# City of Granite City

October 4, 1991

**SUBJECT: NL/TARACORP SITE - REMEDIAL PLAN - WELL LOCATION**

Proposed Wells and Geotechnical  
 Borings - Industrial Area

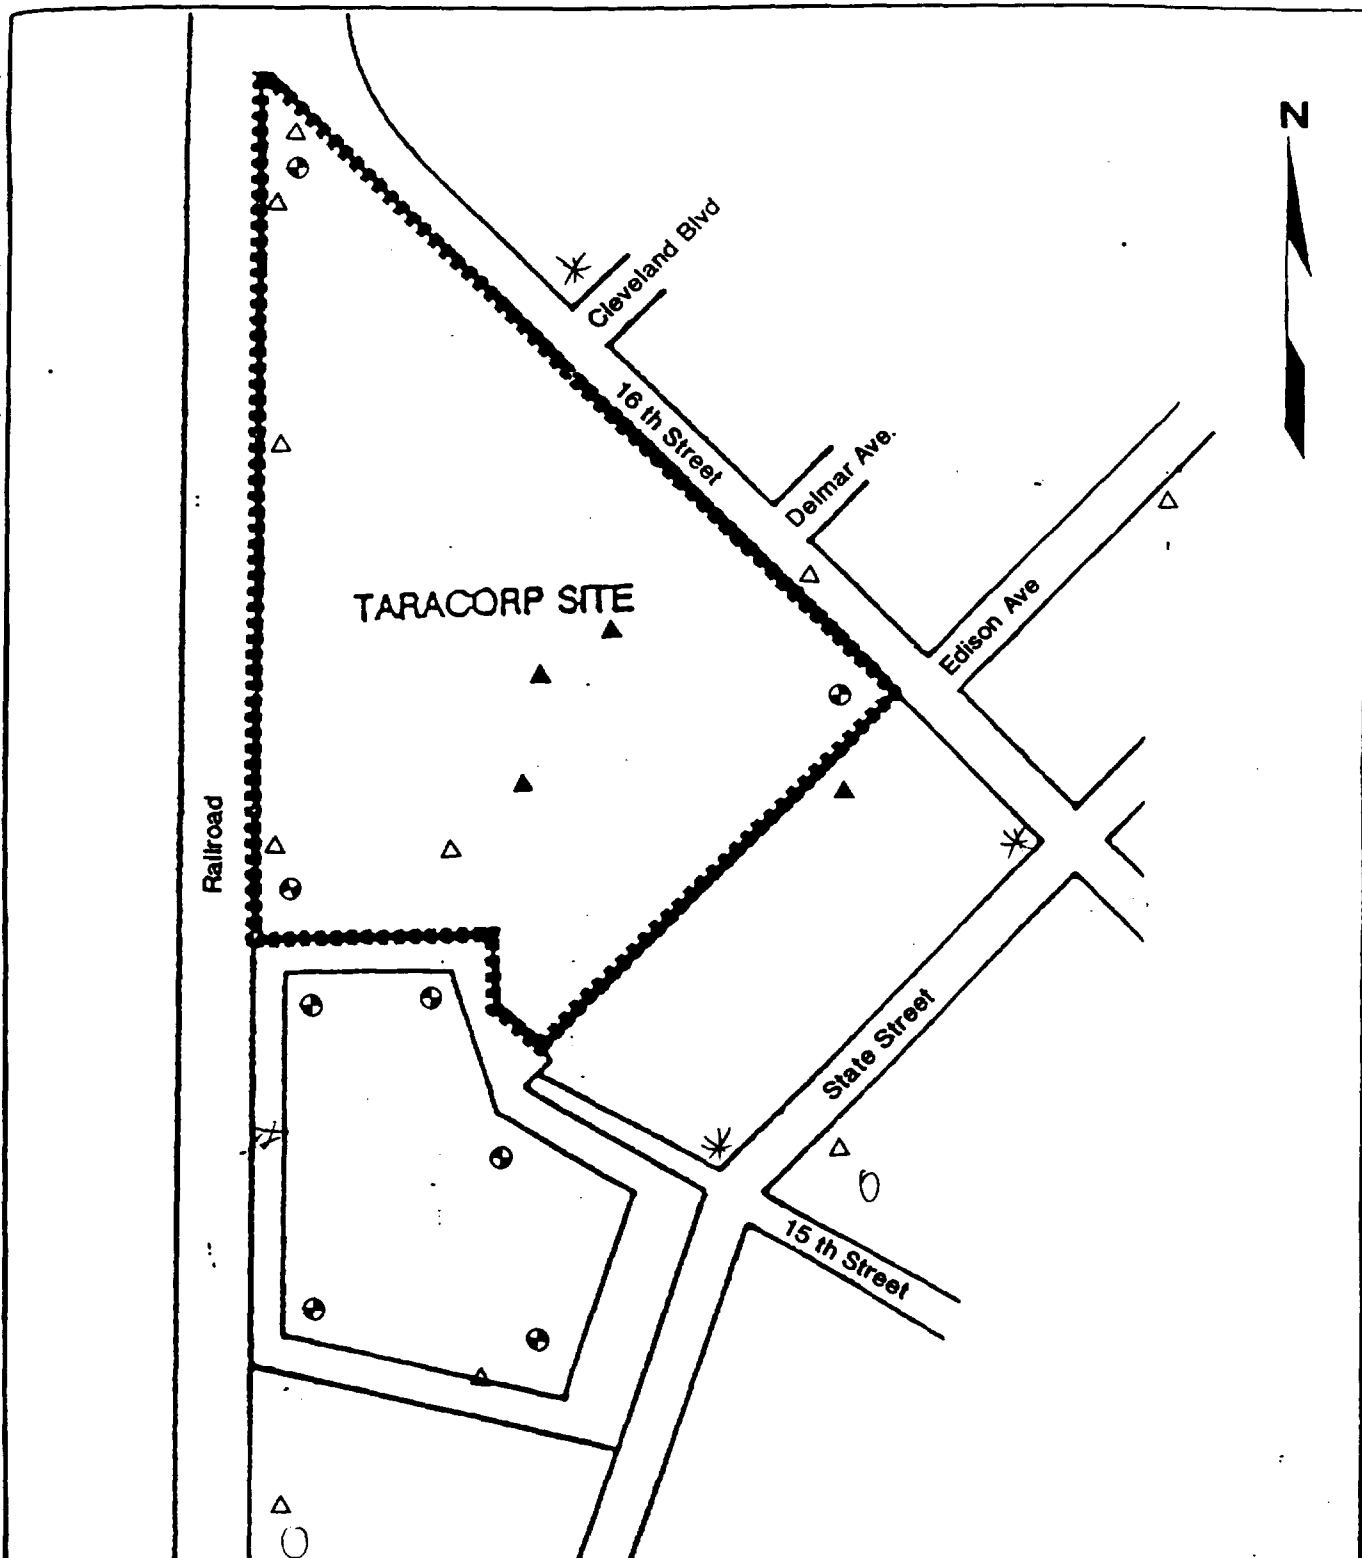
Whereas the subject plan provides for several borings, the marginal expense for lead testing at intervals of 1 1/2 feet between 10 and 20 feet of depth would be minimal. It would be most informative to take seepage groundwater grab samples at the top of the groundwater aquifer to determine what the localized contamination level is. Normal sampling is performed from a deep well with a screen located much deeper than the groundwater surface. The sampler is also purged. Both of these factors preclude an accurate measure of localized groundwater contamination.

The chosen locations are too few, too close to the pile, and poorly distributed. Recommended soil from geotechnical borings and proposed wells be sampled at 1 1/2 foot intervals from 10 to 20 feet deep. Also recommend that at a minimum, four additional deep well borings be made at: Cleveland and 16th Street, State and 16th Street, State and 15th Street, and on the West edge of the SLLR site. These are minimal measure suggested to optimize your proposed efforts.
